MPC Paper No. 9/19

Further Consideration of the Submission for Compliance with  
Approval Condition (j) of Application No. A/H4/94

Proposed Alteration and Modification Works to the Building  
and External Façade for Cultural/Leisure/Retail/Food &  
Beverage Uses/Open Space/Ancillary Support, for the Central Market  
Revitalization Project in “Other Specified Uses” annotated  
“Building with Historical and Architectural Interests Preserved for  
Commercial, Cultural and/or Community Uses” Zone,  
The Former Central Market, 80 Des Voeux Road Central, Central, Hong Kong

FIGURE 2.6  
PROPOSED PART-TIME PEDESTRIANIZATION  
(DURING NON-BUSY HOURS)

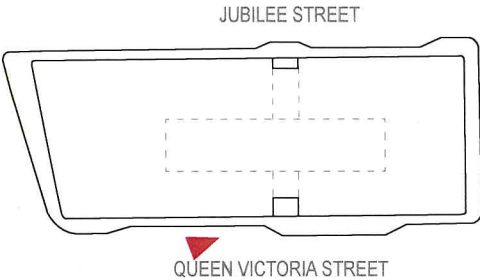
- b) During non-busy hours (7pm to 7am tentatively), removable crash gates would be installed on carriageway. The on-street lay-by (carriageway) would be used by pedestrians and the bollards would be removed during this period (illustration in Figure 2.6).

1. Vehicles may illegally parked at the proposed part-time pedestrianisation zone which may affect the daily installation of crash gate and formation of pedestrianisation zone. As far as we understand, HyD, the works agents for installation and removal of the crash gates, is not authorised to remove such vehicles. Daily assistance from Police may need to be sought.
2. Moreover, the photomontage of applicant's proposal has not reflected the real appearance of the pedestrianisation zone as traffic signs of pedestrianisation zone and no-stopping restriction (NSR) are missing, and the crash gates should be in red according to HyD's standard.
3. In order to maintain smooth traffic, 24-hour NSR should be designated at the portion of Jubilee Street near the widened footpath, i.e. the purple area on Figure 2.1A.

FIGURE 2.1B

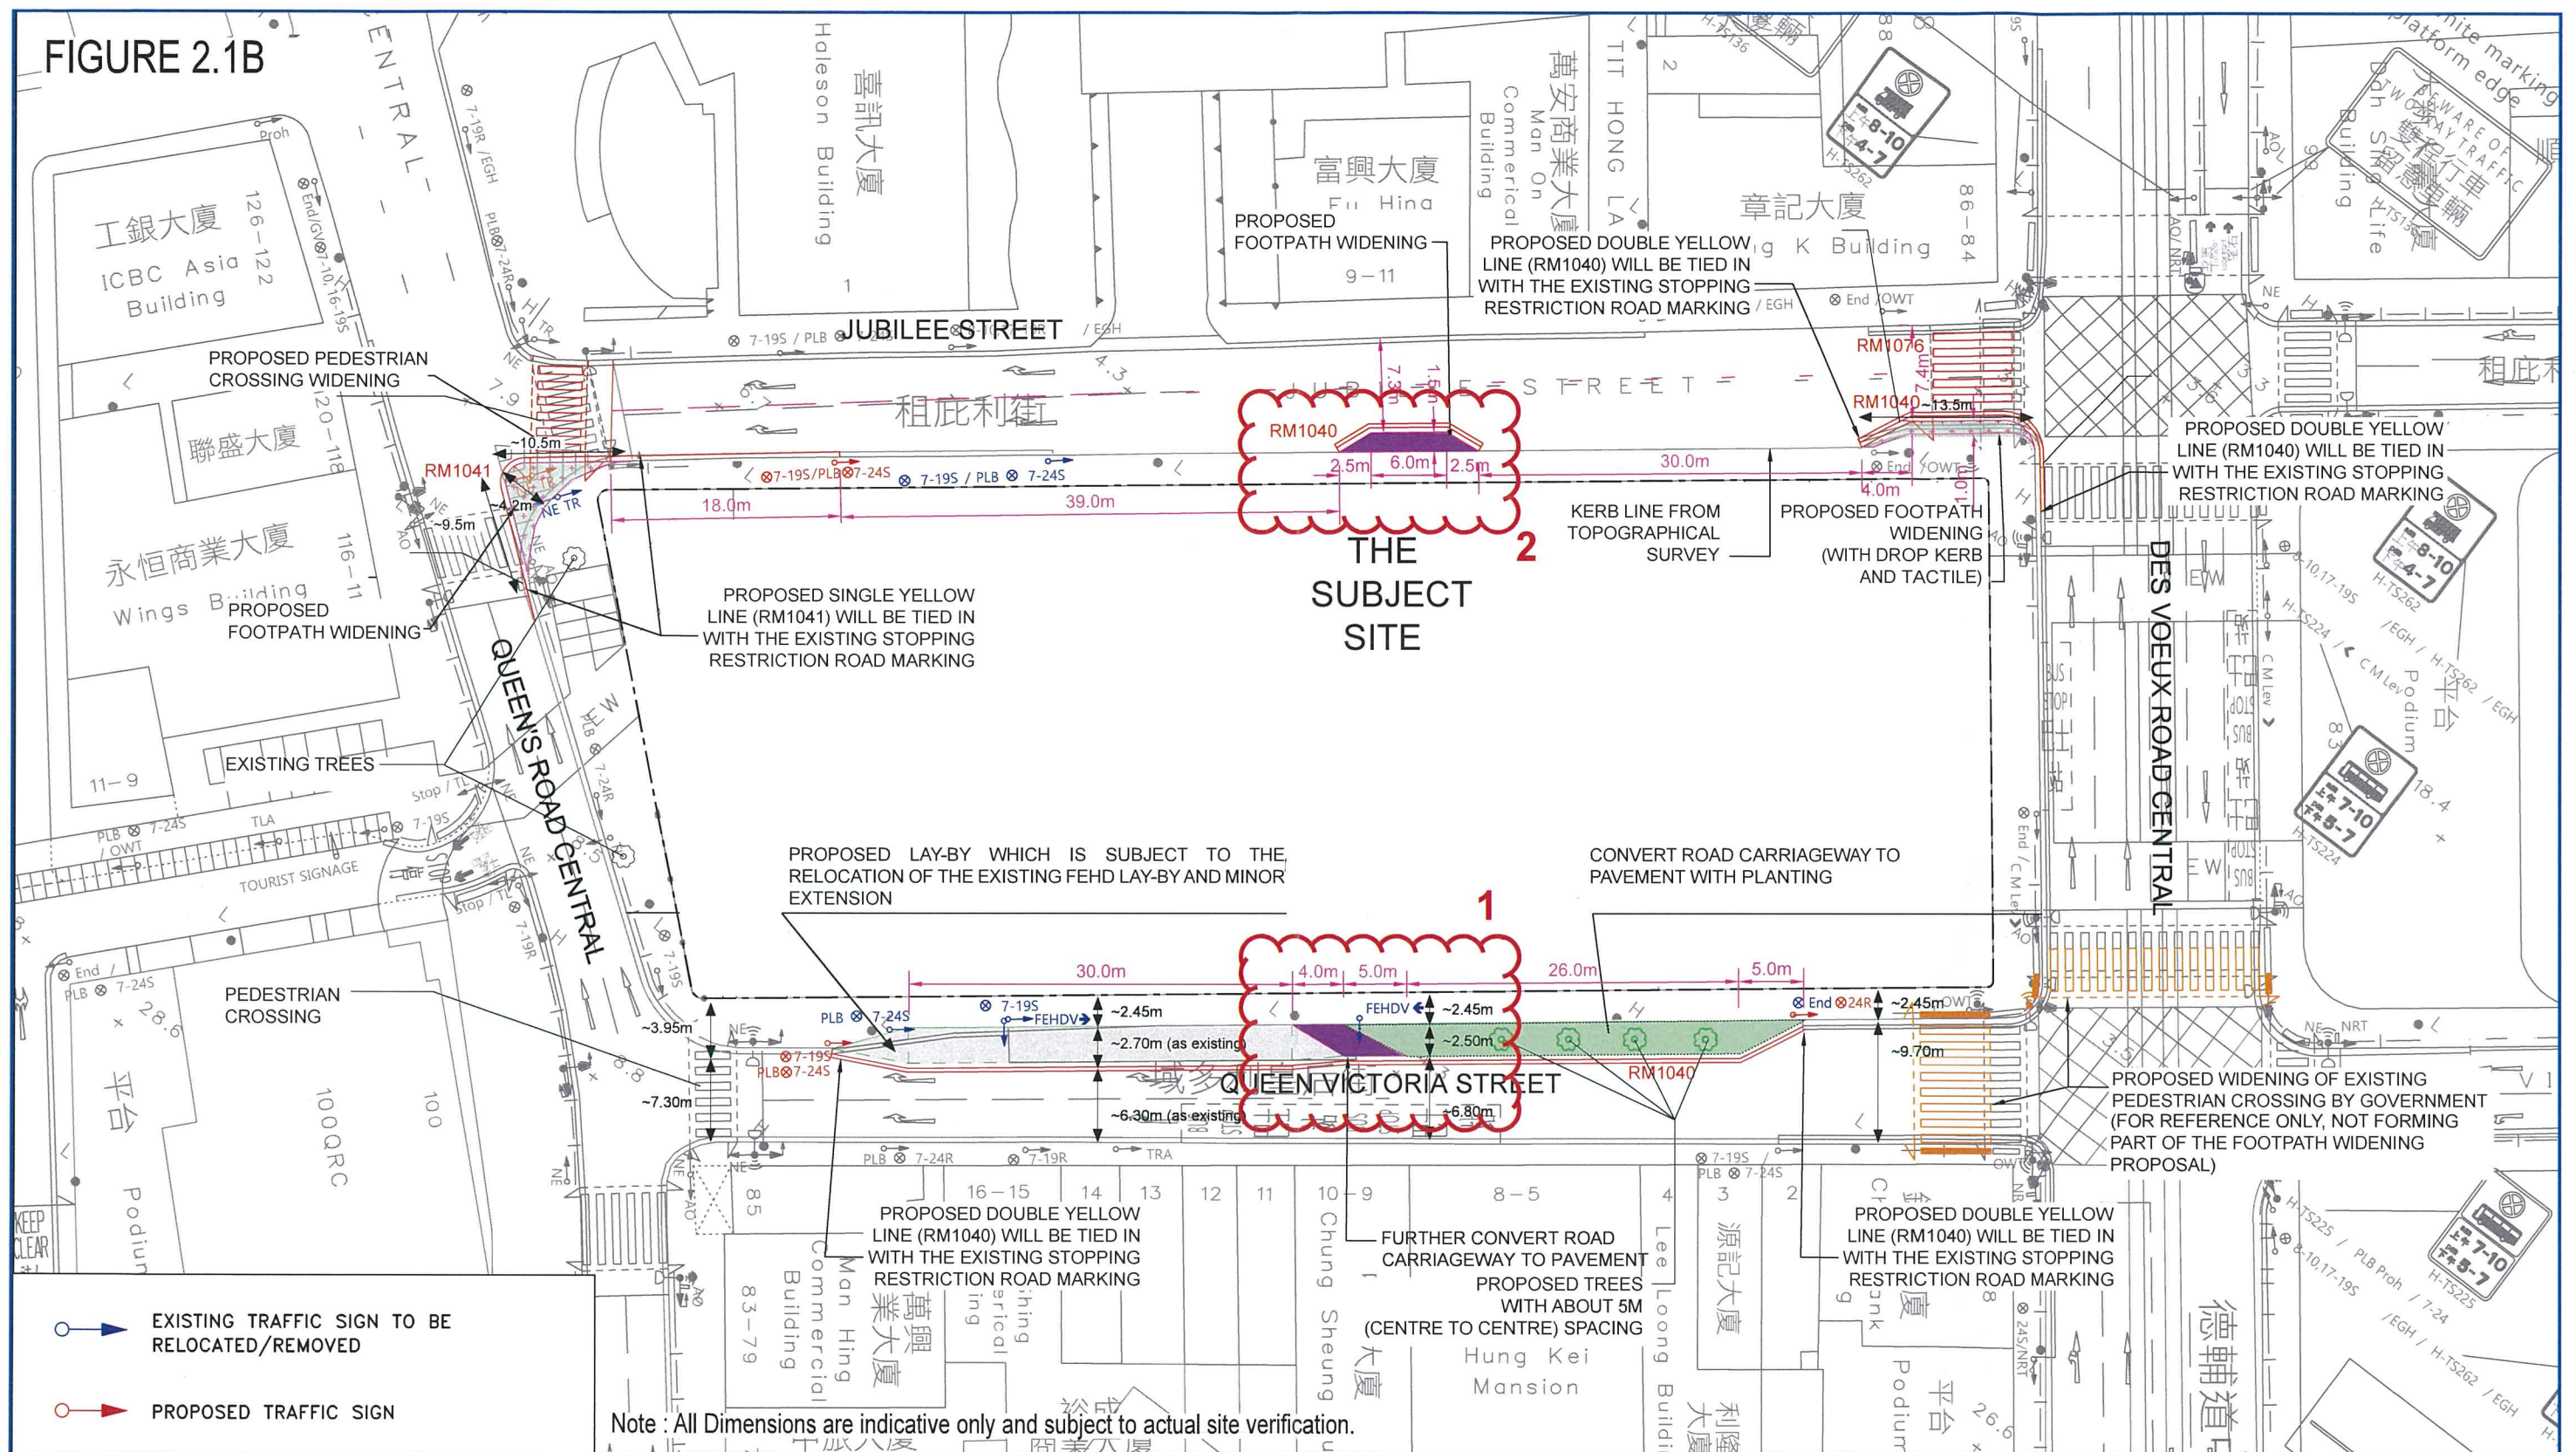
1. The extent of pavement widening in front of G/F entrance facing Queen Victoria Street is further increased by 4m (purple area on Figure 2.1B), as compared with the proposals dated 18 Feb 2019 and 8 May 2019, resulting in a total length of about 40m widened pavement along Queen Victoria Street. No part-time pedestrianization is proposed.
2. Pavement widening is provided in front of G/F entrance facing Jubilee Street about 11m long (purple area on Figure 2.1B).
3. Total length of existing 99m kerbside lay-by is maintained to cater for the demand for loading/unloading activities at Queen Victoria Street and Jubilee Street as required by TD.
4. Please refer to attached replacement drawings (Figures 2.1B, 2.2B, 2.4A, 2.7A and 3.3B) and supplementary drawing (Figure 2.8).

FIGURE 2.7A  
PROPOSED FOOTPATH WIDENING AT JUBILEE STREET  
IN CONNECTION TO THE ENTRANCE WIDENING PROPOSAL

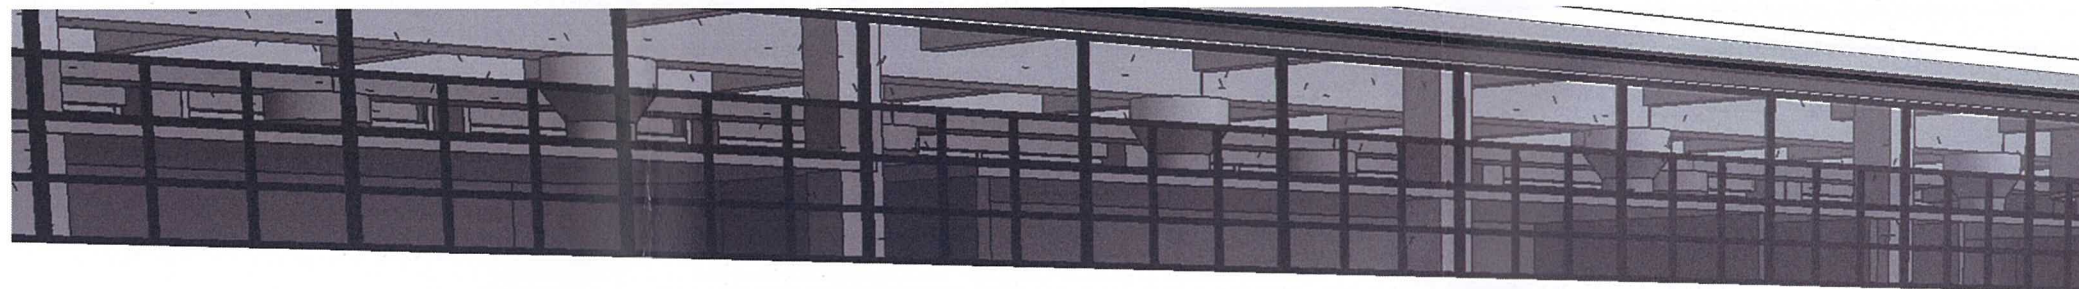
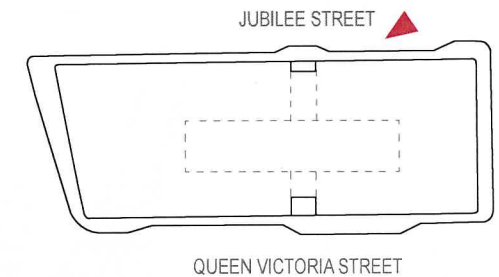
- (b) for the eastern side of Jubilee Street, it is proposed to convert part of the road carriageway of about 6m in length fronting the entrance of Central Market into footpath such that the total width of that section of the footpath is increased by 1.5m, without compromising a two-lane traffic along Jubilee Street as per TD's advice. While the lay-by along Jubilee Street would be split into two sections of 39m and 30m, the total length of lay-by along Jubilee Street is increased by 4m from about 65m to 69m for reprovioning of the reduced lay-by length at Queen Victoria Street (**Drawings AA-1 and AA-4**).

FIGURE 2.1

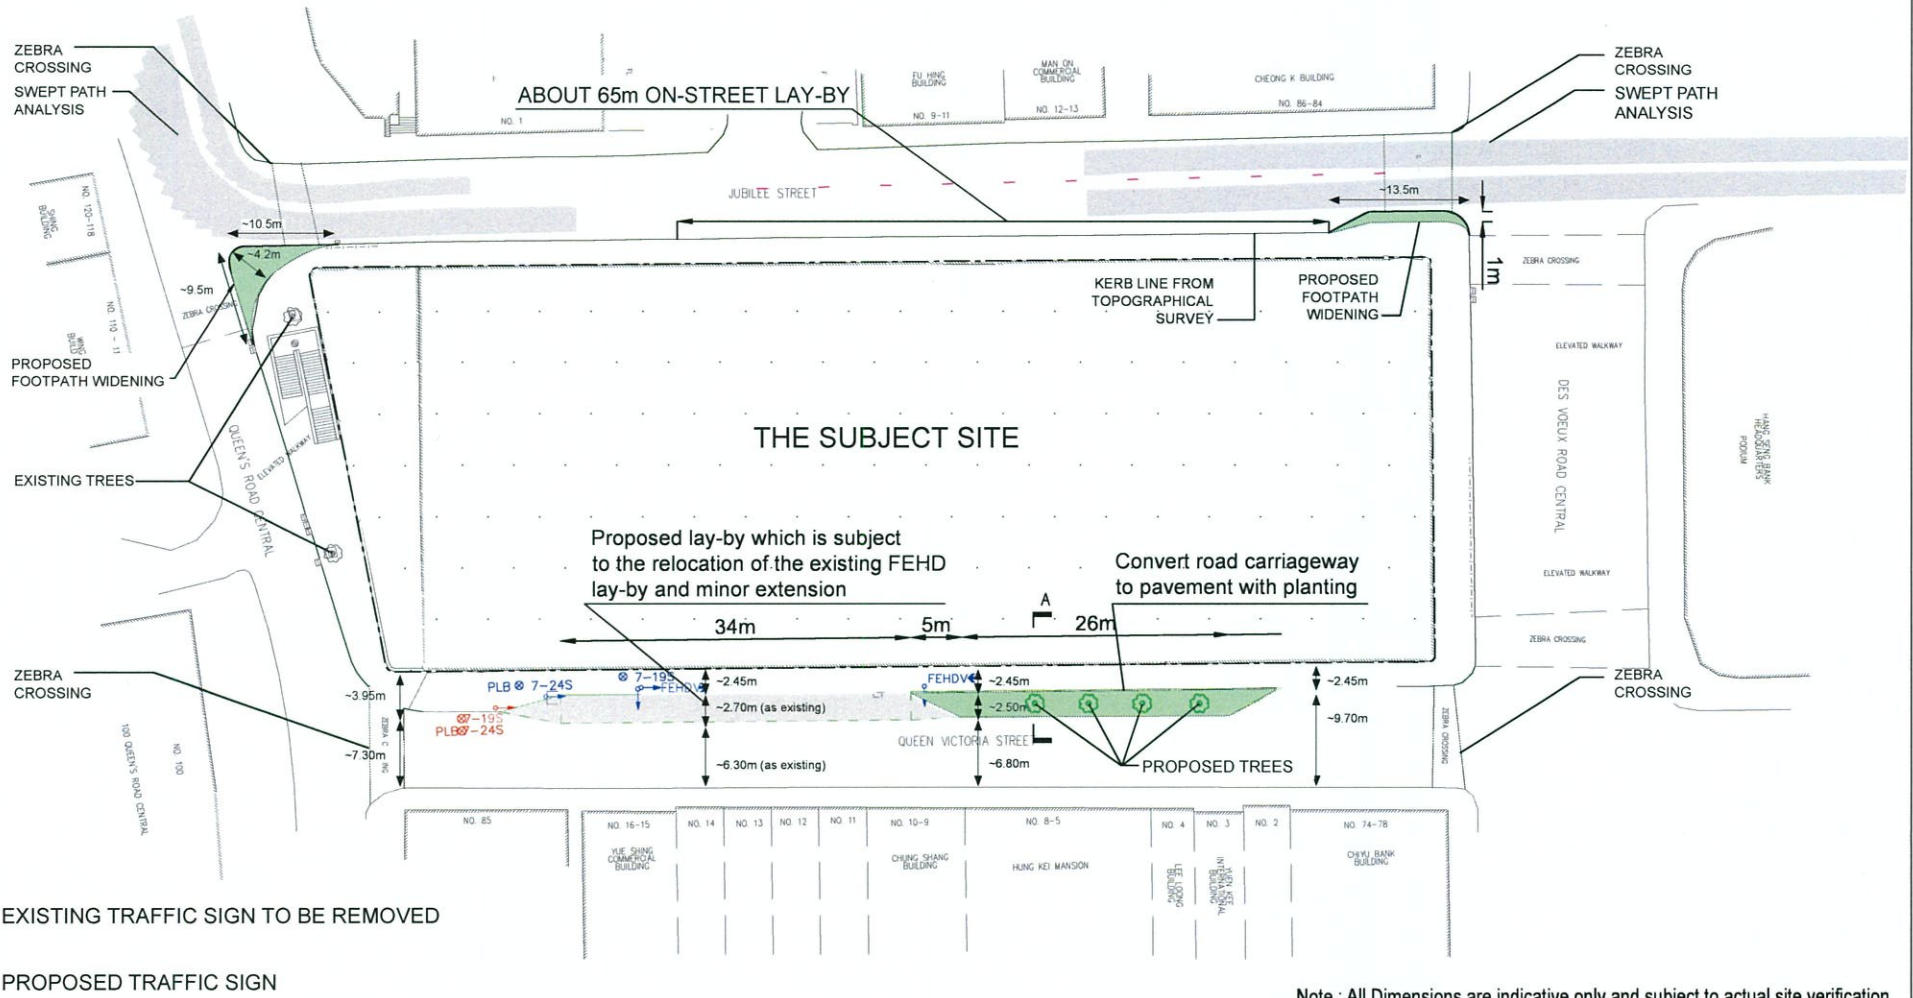
- 2.1.1 The area shown coloured green on **Figure 2.1** is proposed to be widened to enhance pedestrian environment. The associated traffic signs and road marking shall be provided and the obsolete traffic signs are removed.
- 2.1.2 The existing 28m FEHD lay-bys on Queen Victoria Street would be relocated to provide space for on-street lay-by for loading/unloading. FEHD lay-bys will be re-provided at Eastern Street North (21M) and Pier Road (7m) respectively (refer to **Appendix D** for details). The length of the on street lay-by is proposed to further extend 6m to about 34m by modifying the kerblines as per **Figure 2.1**.
